Well Name: SAN JUAN 28-5 UNIT	Well Location: T28N / R5W / SEC 23 / SWSE / 36.641307 / -107.326049	County or Parish/State: RIO ARRIBA / NM
Well Number: 103M	Type of Well: CONVENTIONAL GAS WELL	Allottee or Tribe Name:
Lease Number: NMSF079519A	Unit or CA Name: SAN JUAN 28-5 UNIT--DK, SAN JUAN 28-5 UNIT--MV	Unit or CA Number: NMNM78411A, NMNM78411B
US Well Number: 3003925957	Operator: HILCORP ENERGY COMPANY

Subsequent Report

Type of Action: Temporary Abandonment

**Subject:** [EXTERNAL] TA Revision Request for Hilcorp's SAN JUAN 28-5 UNIT 103M (API # 3003925957)

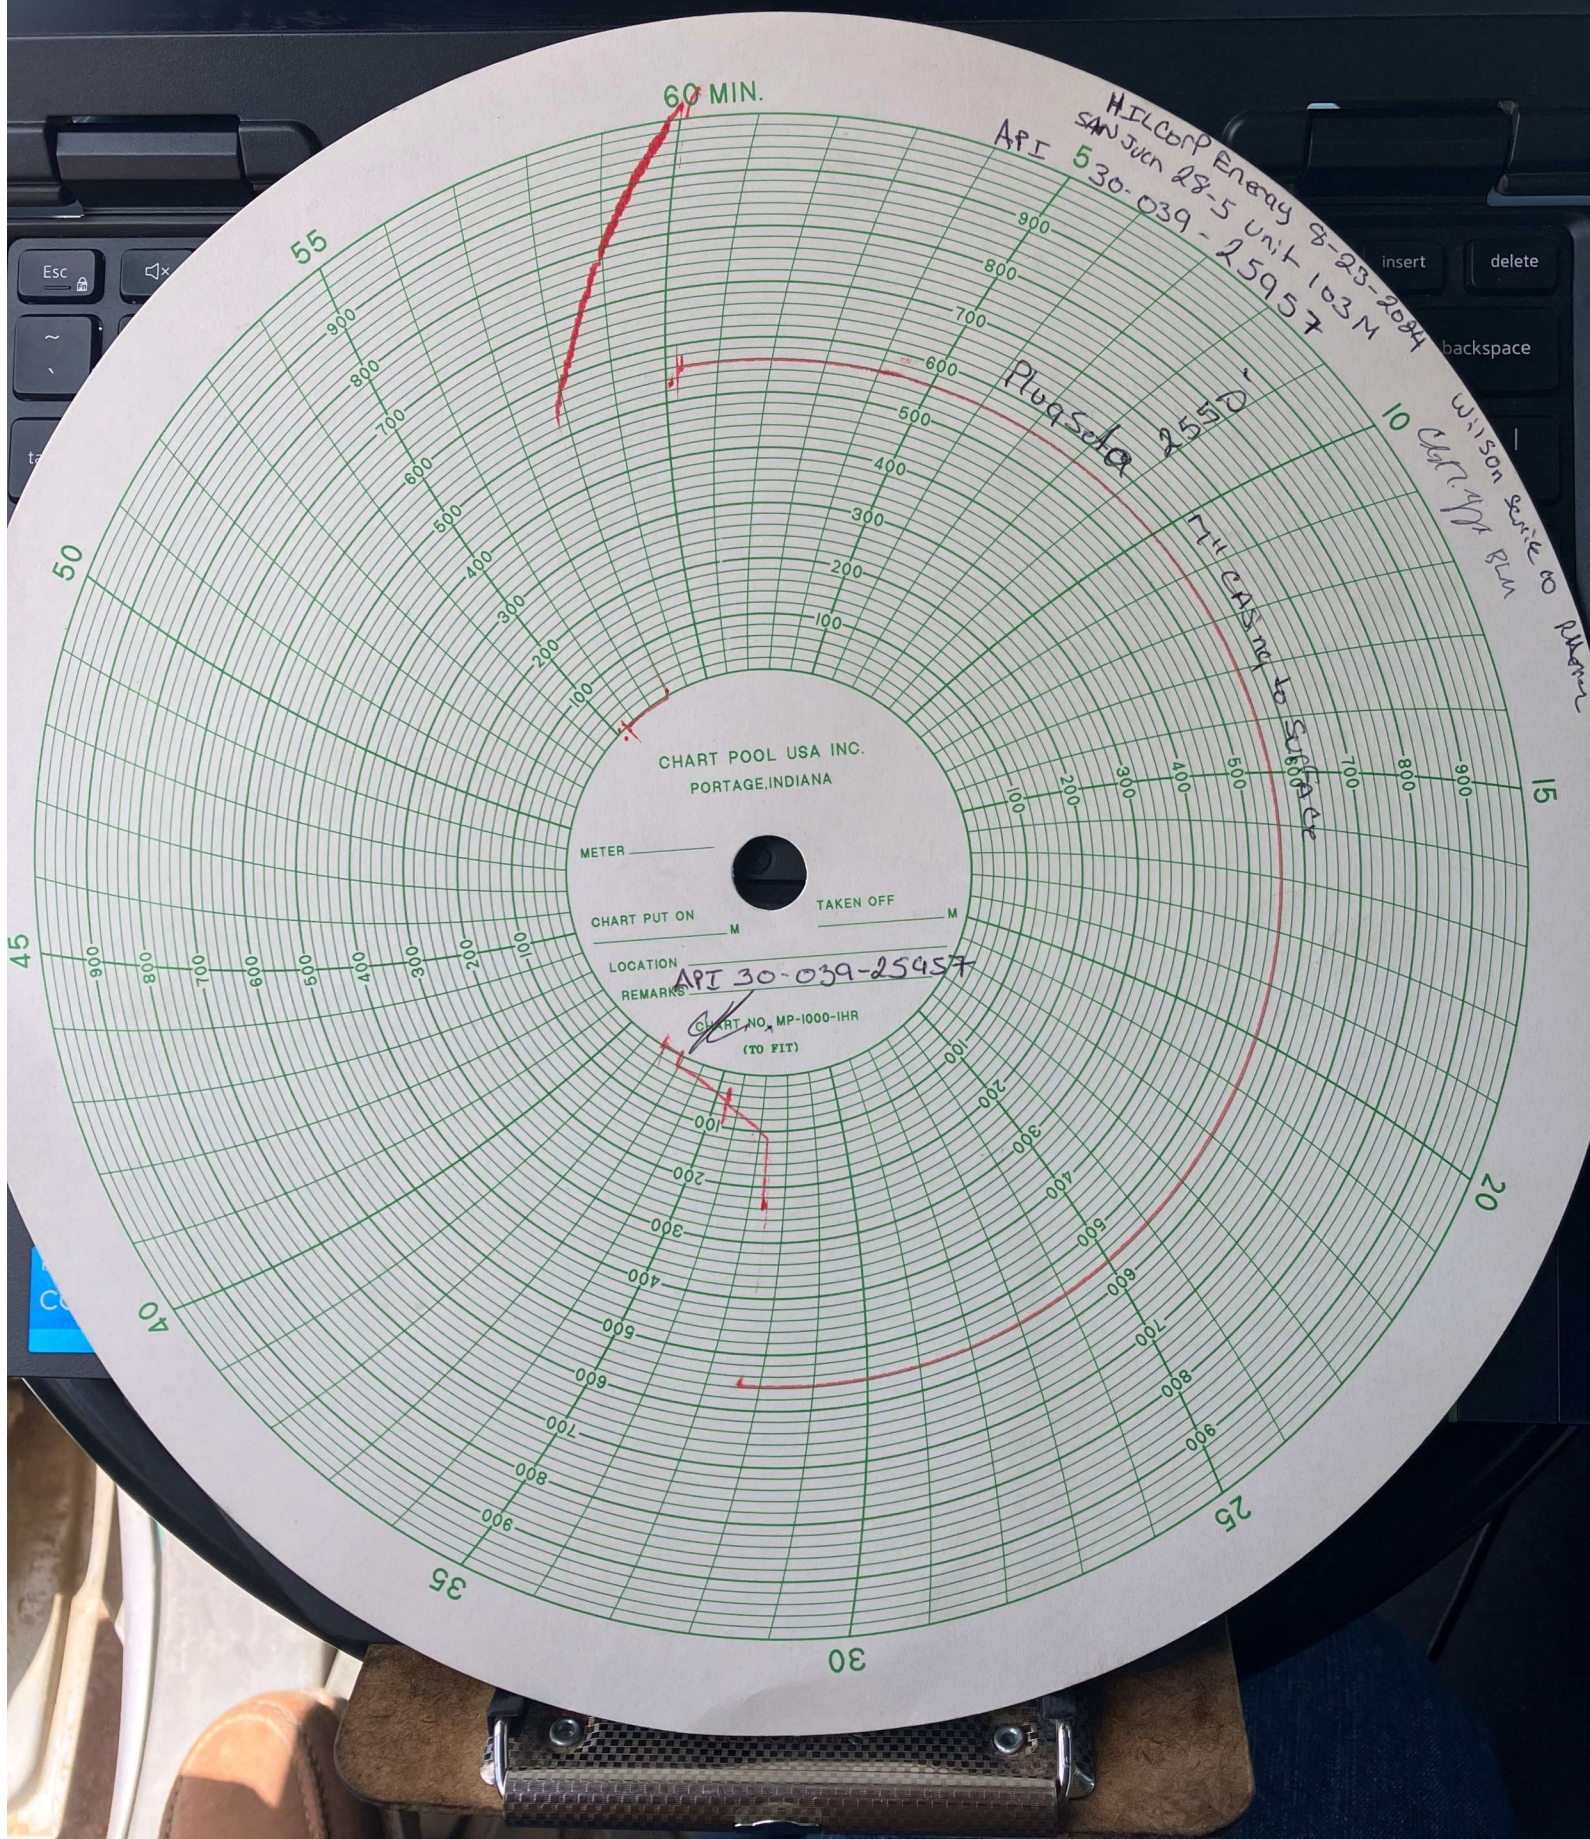
Based on the COAs, Hilcorp requests the following adjustments to the approved procedure:

- PLUG #7 has been added to cover the chemically cut casing @ 2,718'.
- The **7" CIBP will now be set @ 2,550'** instead of the originally approved 2,700'.

Please see the revised procedure attached and below. The updated Proposed TA wellbore schematic is also attached.
